102. EPoC PHY Link

Modify Figure 102-1 and 102-2 as shown below

Figure 102–3—Downstream PHY Link frame

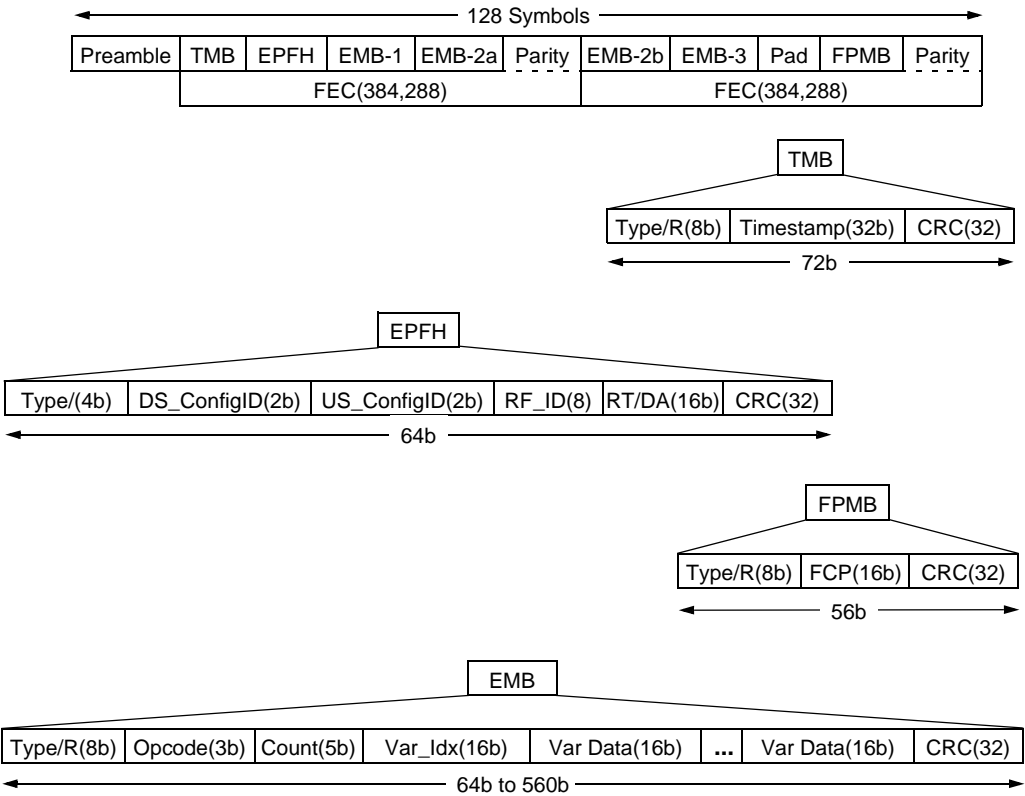
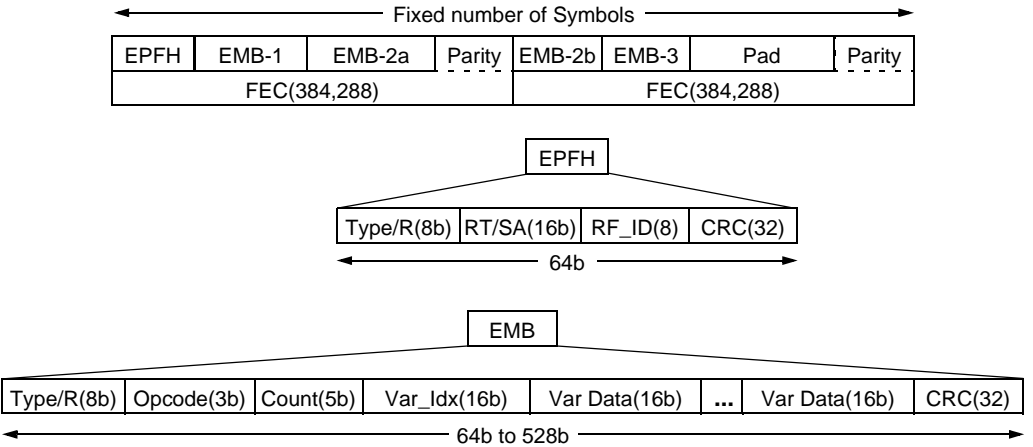
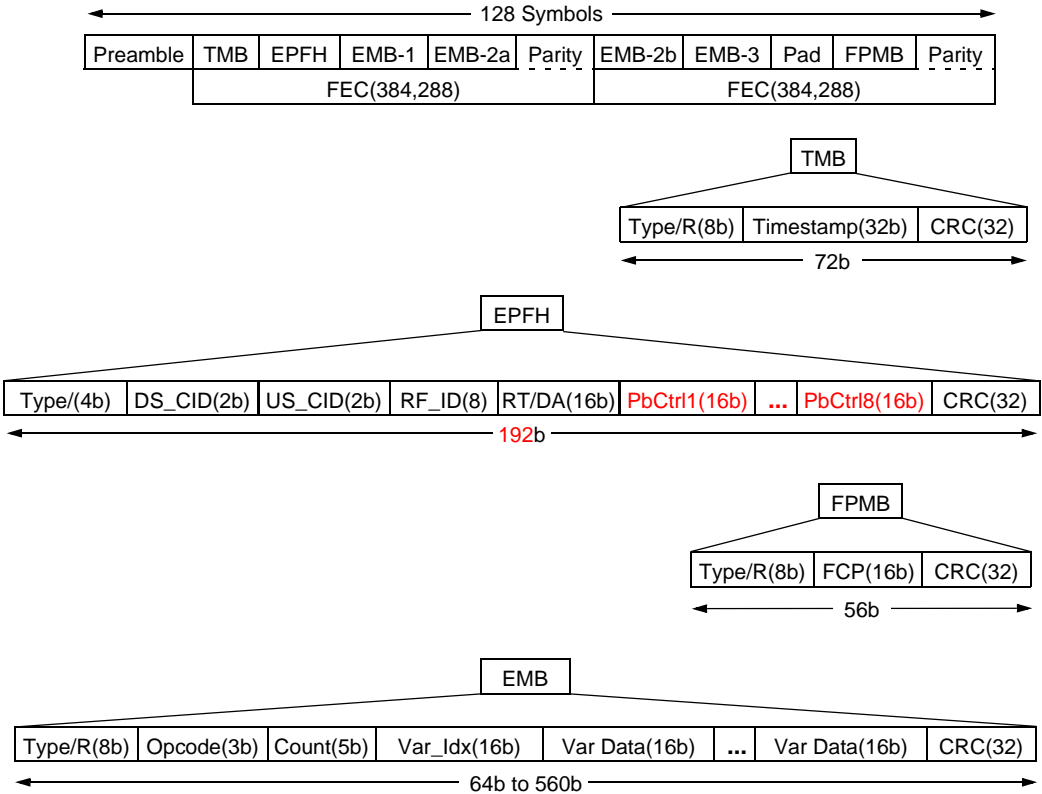
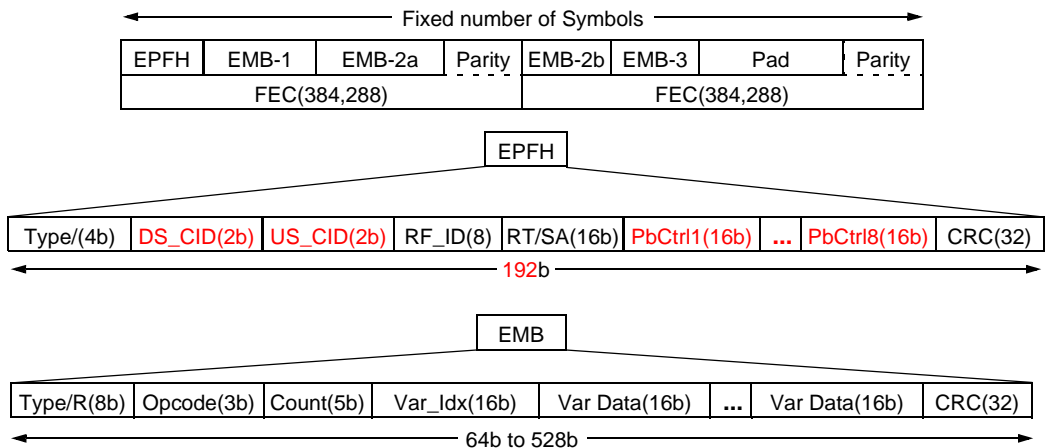
The downstream PHY Link uses a fixed frame format, illustrated in Figure 102–3, that the 128 symbol staggered pilot pattern is aligned with, as described in 101.4.3.5.1. The 128 symbol downstream PHY Link frame is composed of a Preamble (see 102.2.2), one 32-bit Timestamp message block (TSMB), one 192-bit EPoC PHY Frame Header (EPFH), some number of variable length EPoC message blocks (EMP), one 56-bit FEC Parity message block (FPMB), and padding. The message blocks within the frame are protected with a FEC mechanism. Each message block and it's included fields is described below. The number of optional EPoC message blocks contained within the frame is limited only by the frame size.

Figure 102–8—Example, all subcarriers used for probing, no skipping

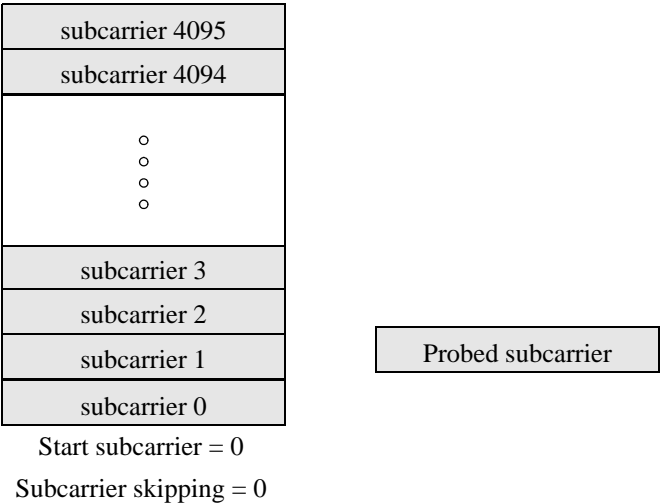
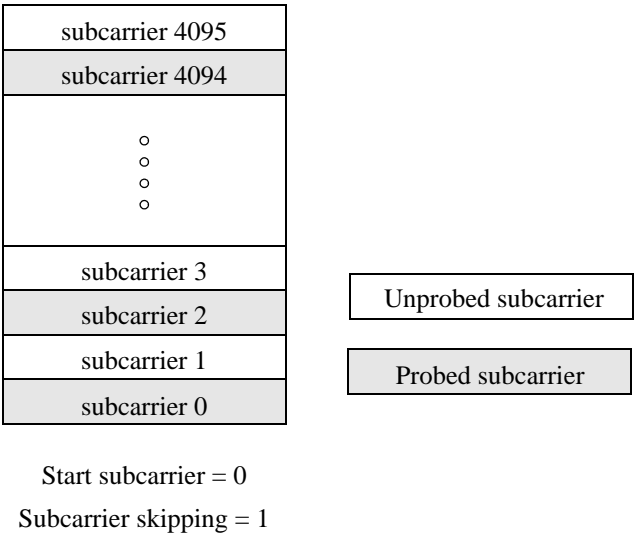
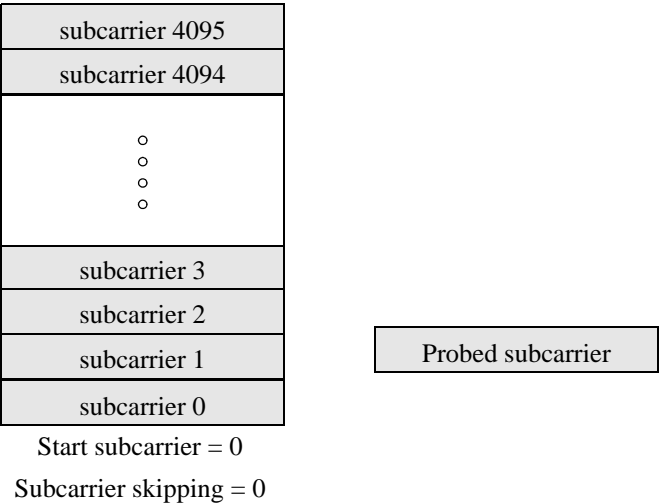
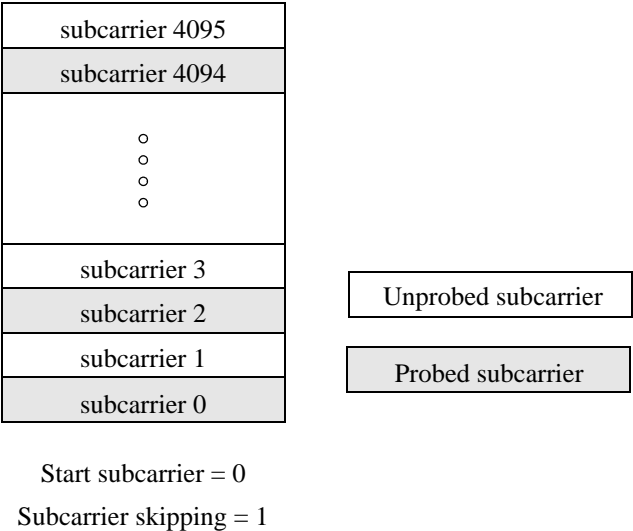
The CLT allocates subcarriers within a probing symbol by sending ~~two~~five variables to the CNU: ~~ProbeStart~~PrbStrtSC, ~~PrbSkep~~PrbEQ, ~~StrtSym~~PrbSym and ~~ProbeSkip~~PrbSkep. ~~The range of ProbeStart is from 0 to 7. The range of ProbeSkip is from 0 to 7.~~SymNum (see 102.4.3.6). Figure 102–8 and Figure 102–9 illustrate the use of ~~these variables~~PrbStrtSC and PrbSkep. The CNU uses the start subcarrier and subcarrier skipping parameters to determine which subcarriers are to be used for probing transmission, as follows:

To schedule a single CNU in a probing symbol with skipping ~~subcarrier s~~ subcarriers to create nulls (as illustrated in Figure 102–9), the CLT does the following:

Figure 102–11—Scheduling two CNU in the same probing symbol

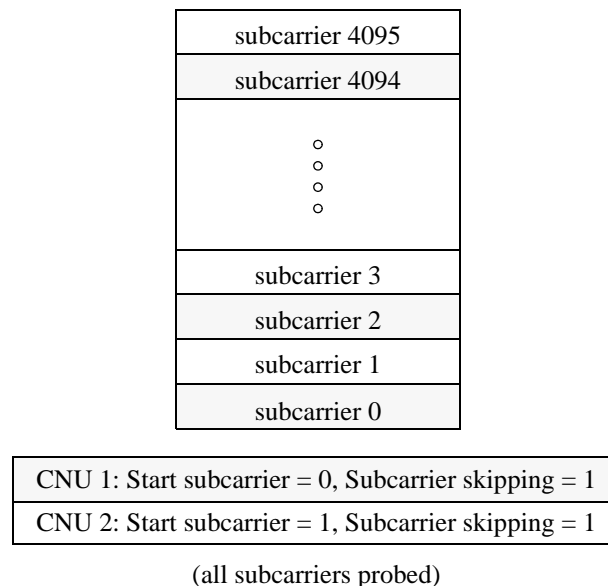
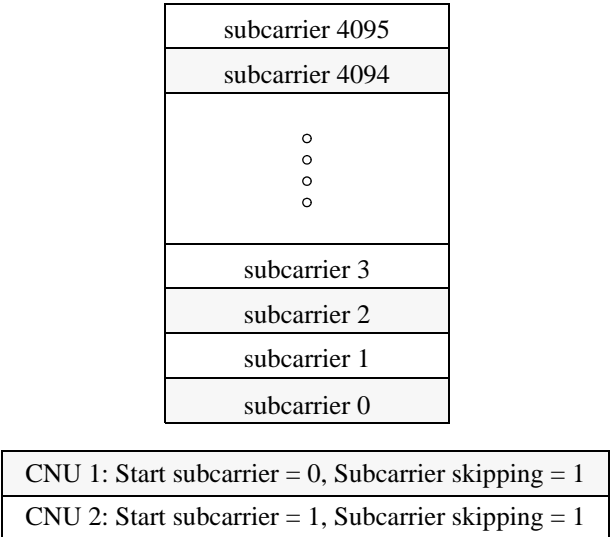
To schedule multiple CNUs in a probing symbol (as illustrated in Figure 102–11) the CLT does the following:

- 1) Allocate the same probing symbol at any given time to more than one CNU.
- 2) Assign a different ~~ProbeStart~~ PrbStrtSC number to each CNU.
- 3) Assign the same ~~ProbeSkip~~ PrbSkp value to every CNU within the probing symbol.

This method can be used with or without skipping subcarriers to create nulls. To create nulls, specify a ~~ProbeSkip~~ PrbSkp value equal to, or greater than, the number of CNUs in the pattern.

Figure 102-13—Probe sequence generator

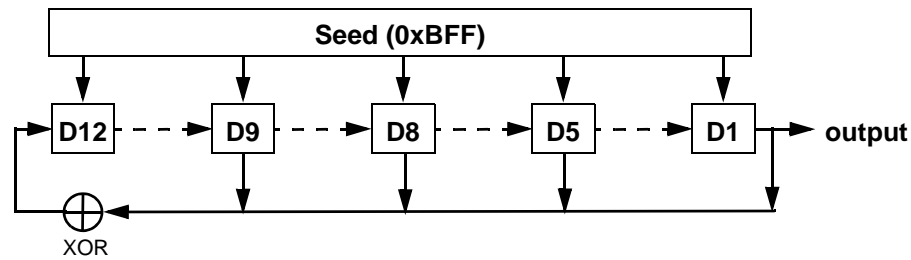
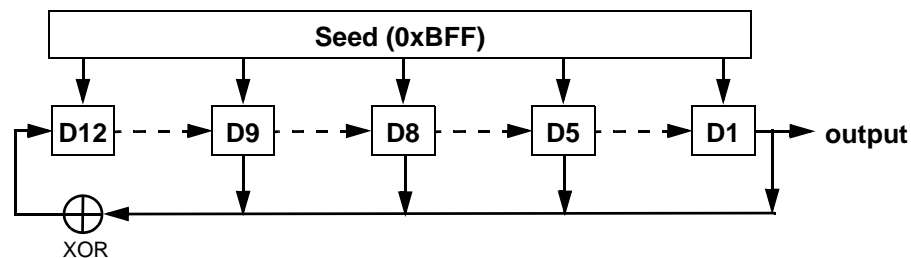
The Probe symbol shall be populated with a BPSK mapped bit sequence generated by a pseudo-random sequence generator defined by the polynomial $X^{12} + X^9 + X^8 + X^5 + 1$ seeded with a fixed bit pattern of 0xBFF at the beginning of each upstream superframe (illustrated in Figure 102–13). The output of the sequence generator is mapped using BPSK modulation (see 101.4.5.2) where a bit value of 0 is mapped to a BPSK value of plus1 and a bit value of 1 is mapped to a BPSK value of minus 1.

Figure 102–14—CNU Probe transmission control state diagram

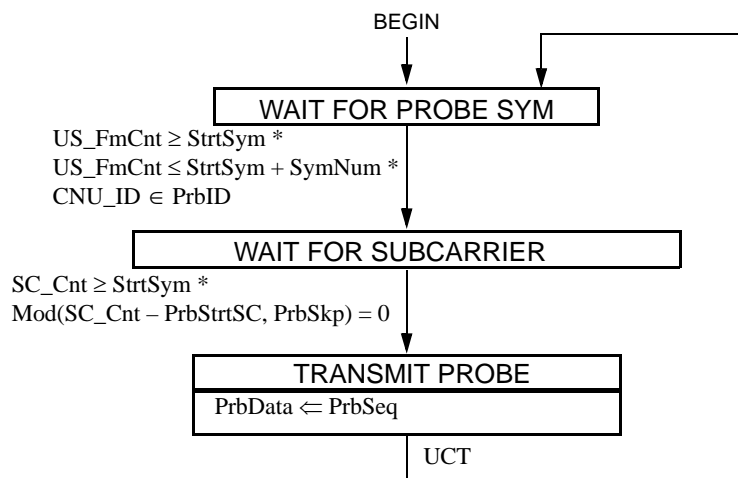
Add section 102.4.3.6 through 102.4.3.9 as shown below.

The CNU probe transmit process shall conform to the state diagram shown in Figure 102–14.

Figure 102–15—PrbID update state diagram

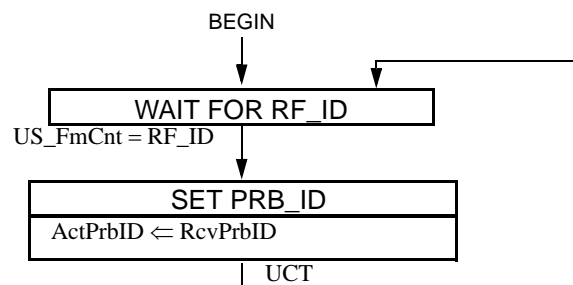
<u>set of variables is updated with each downstream PHY Link frame when RF_ID = US_FmCnt (See Figure 102–15).</u>	1
<u>CNU_ID</u>	<u>See {ref}</u>	2
		3
<u>PrbData</u>	<u>TYPE: bit array</u>	4
	<u>This variable holds the probe sequence bits to be transmitted during the probe period.</u>	5
<u>ProbeDur</u>	<u>TYPE: boolean</u>	6
	<u>This variable determines the number of Symbols in the Probe Period. When ProbeDur is FALSE there are five symbols in the Probe Period, when this variable is TRUE there are six symbols in the Probe Period.</u>	7
<u>PrbEQ</u>	<u>TYPE: Boolean</u>	8
	<u>When this variable is TRUE the CNU transmits the probe symbol with equalization applied. When this variable is FALSE the CNU transmits the probe symbol without equalization applied.</u>	9
	<u>Note the def for PrbEq is included here for clarity but should be placed in Cl 101.4.4.5 Probe generator.</u>	10
<u>PrbSkp</u>	<u>TYPE: Integer</u>	11
